Variance Request Form

Variance: 026
Request No.: Rev 0
Date Submit: 10/11/2012
Date Approval Needed: 10/15/2012
Date Agency Received: _____
Agency Approval Reference No.: _____

OCOTILLO WIND PROJECT: IMPERIAL COUNTY, CALIFORNIA

VARIANCE 26 - OCTOBER 10, 2012

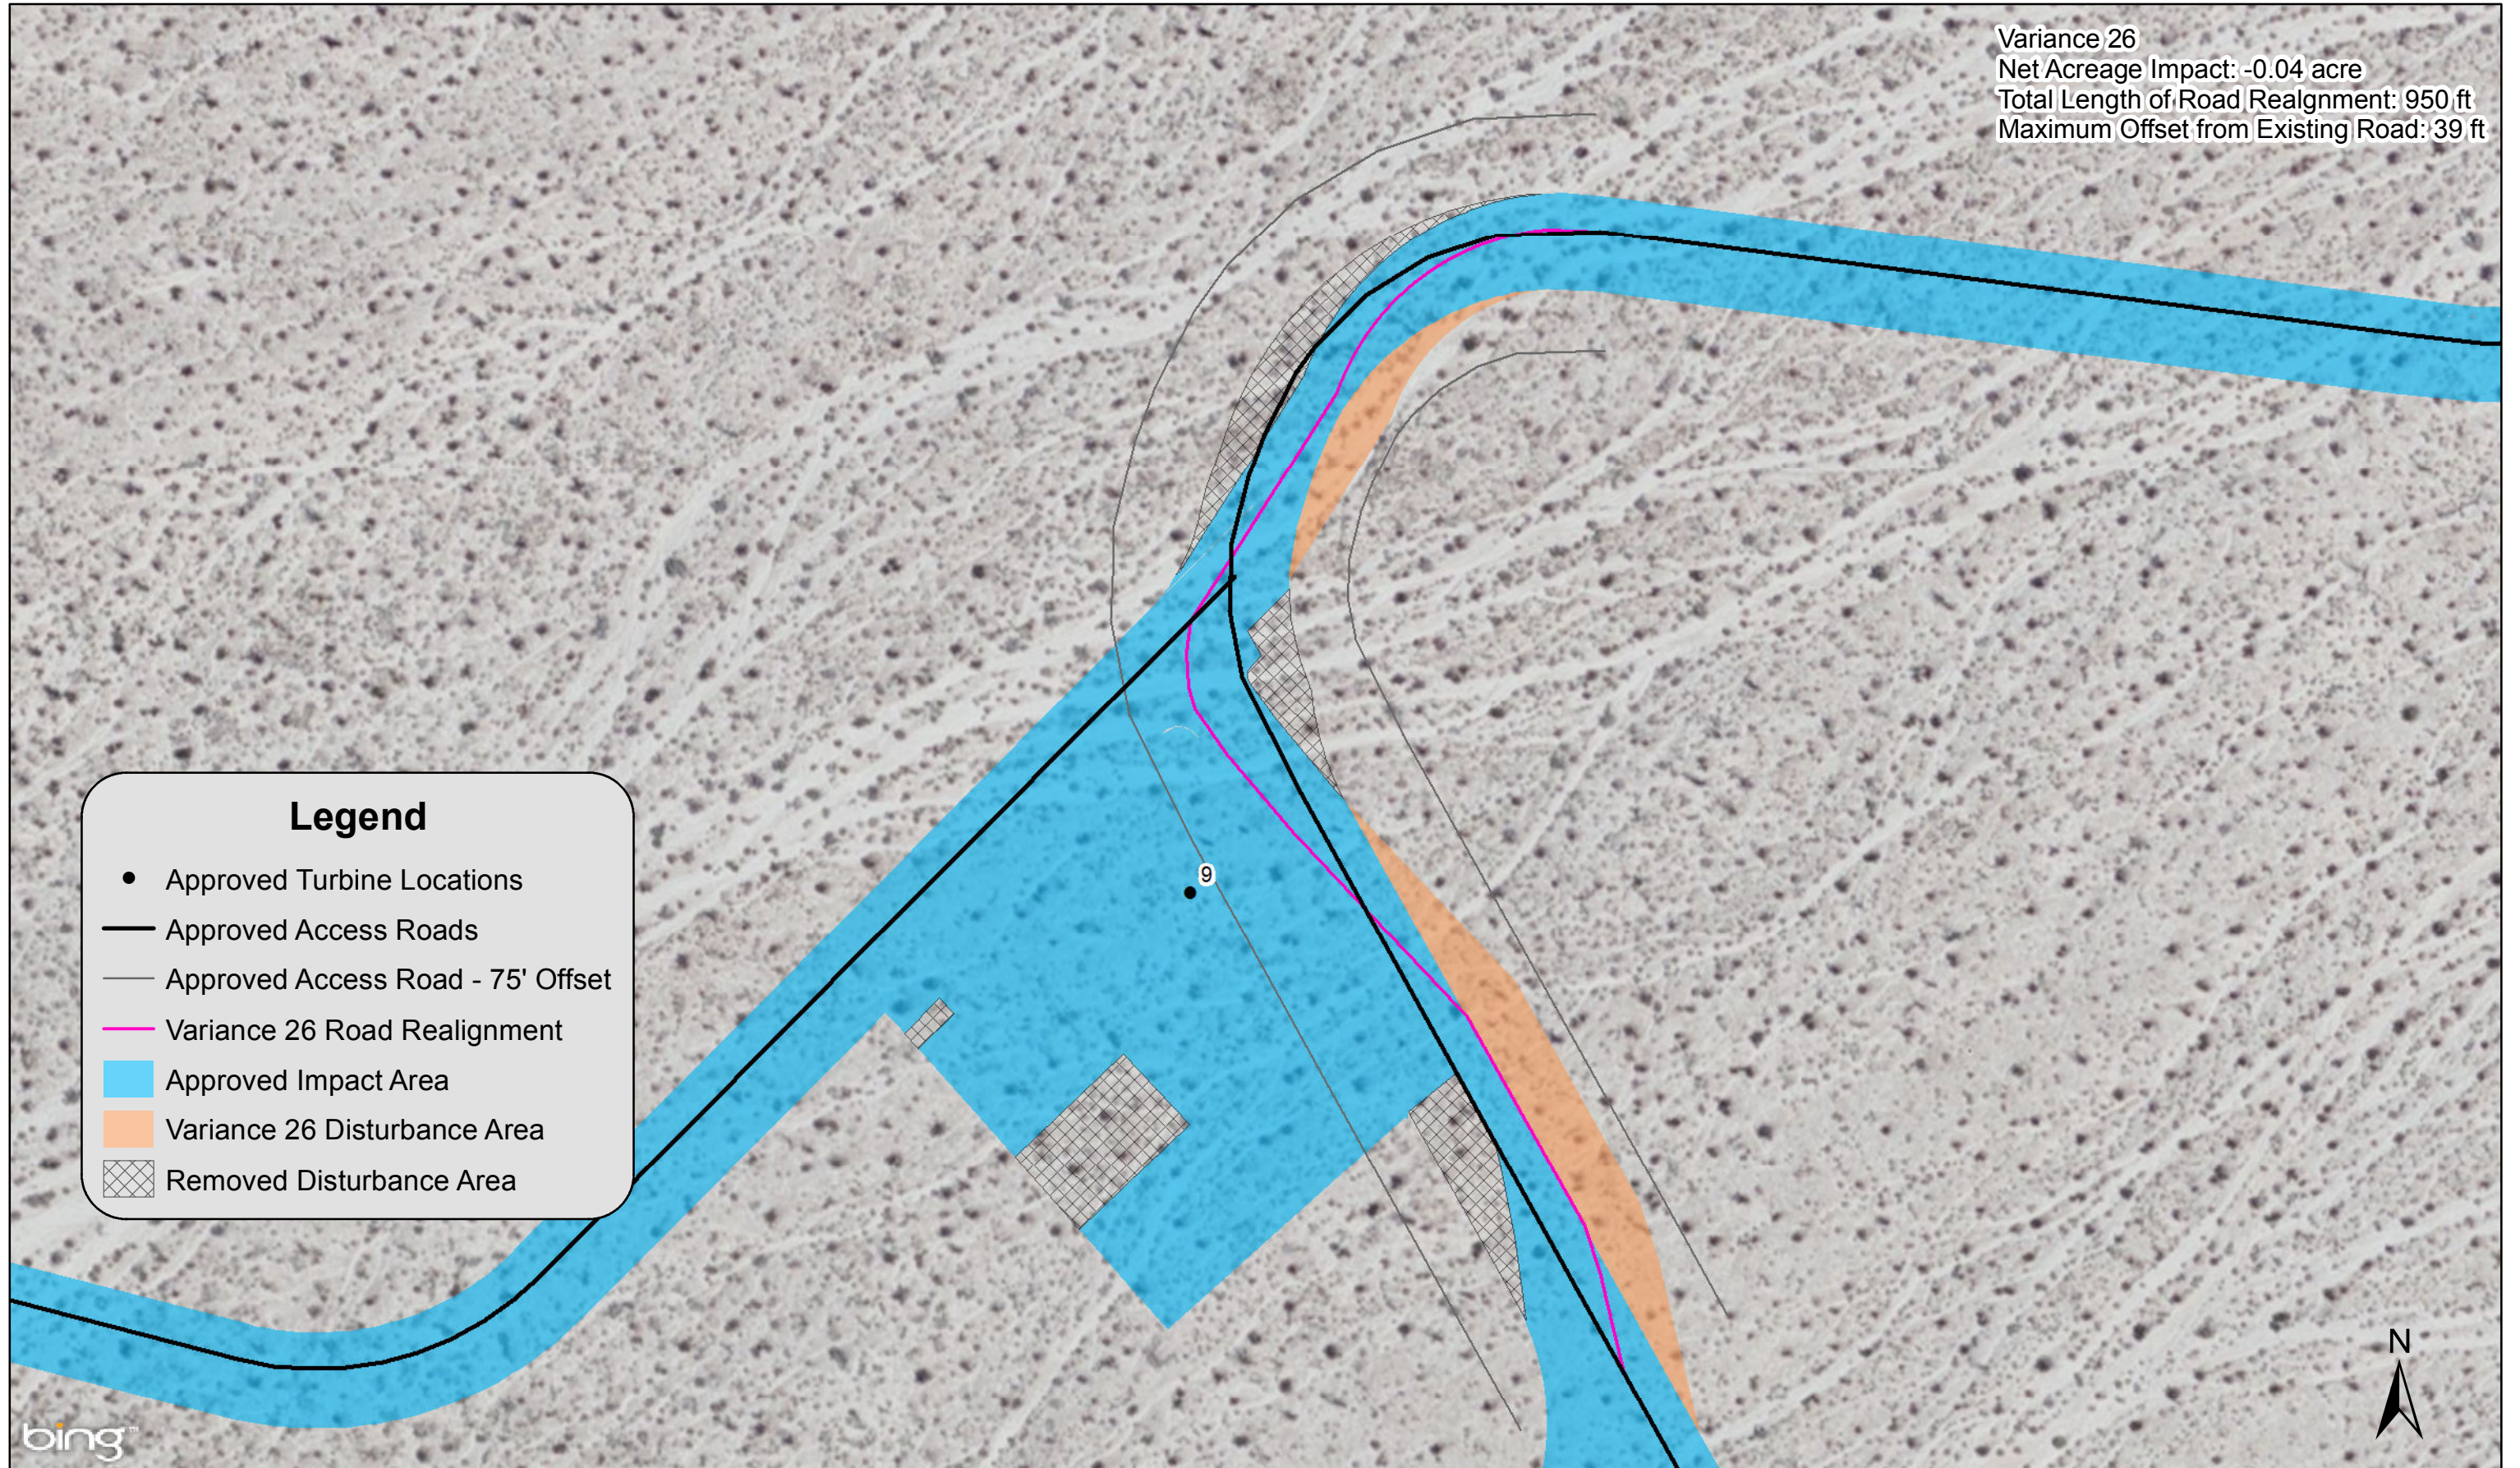
Variance 026 includes modifications to the access road and collection circuit corridor leading into Turbines 9 and 10 (see map attachment). The total length of the access road and collection circuit corridor realignment towards Turbines 9 and 10 is 950 feet with a maximum offset of 39 feet from the currently approved corridor alignment.

Variance 26
Net Acreage Impact: -0.04 acre
Total Length of Road Realignment: 950 ft
Maximum Offset from Existing Road: 39 ft
